PUC Project No. 35077

Second Amendment to the

**ERCOT STANDARD GENERATION
INTERCONNECTION AGREEMENT**

March 29, 2021

Exhibit “C2”
One Line Diagram – TSP Interconnection Facilities, Generation Interconnection Facilities and the Plant

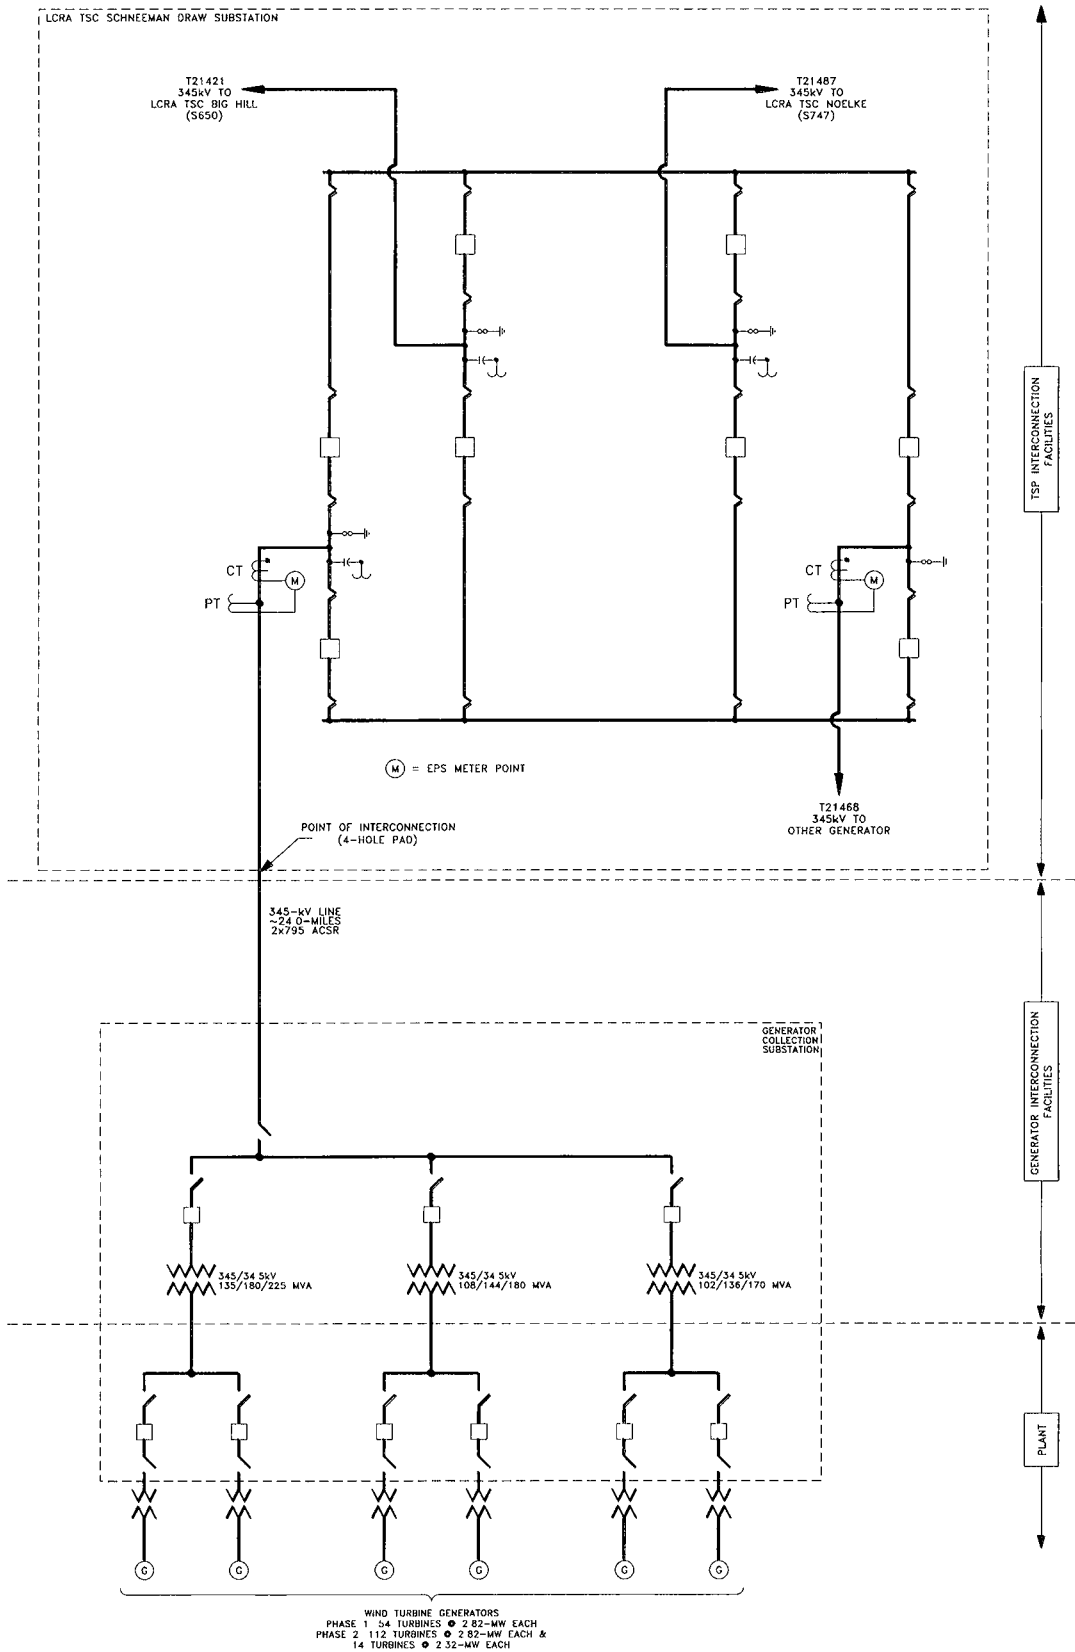
WHEREAS, the Generator notified TSP of a change in the design of the Plant as contemplated in the Agreement; and

WHEREAS, such change in the design of the Plant requires the submission of a new Generation Interconnection or Change Request application to ERCOT.

1. Exhibits "B", "C", "C2", and "D" are deleted in their entirety and the Exhibits "B", "C", "C2", and "D" attached to this Amendment are hereby added to the Agreement in lieu thereof.
2. This Amendment will become effective upon execution by both Parties.
